MEMORANDUM

TO: DEEP RIVER PLANNING & ZONING
FROM: DESIGN ADVISORY BOARD
SUBJECT: BAVOLACK HOUSE – PRELIMINARY DESIGN REVIEW COMMENTS
DATE: 08/20/2010
CC:

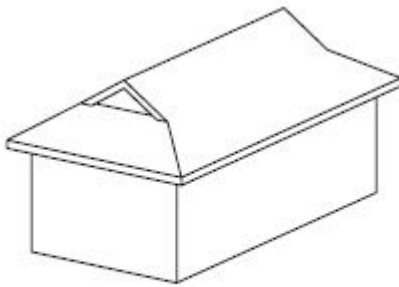
The proposed roofline raises the roof to add a second floor and retains the existing roof slope. The low slope is not typical of the area and the increased building height is out of scale with the immediate context. It was suggested that a roofline more consistent with the street wall be considered. It was suggested that a Jerkinhead Roof be considered since there is precedent for that form in town.

The windows were poorly proportioned and placement was irregular. The most significant problem is with the windows of the existing residential units that will remain. The windows are broad and squat on the lower level with taller windows on the second level. Alignment of windows appears unordered. It was suggested that a more regular pattern and proportion of windows be considered.
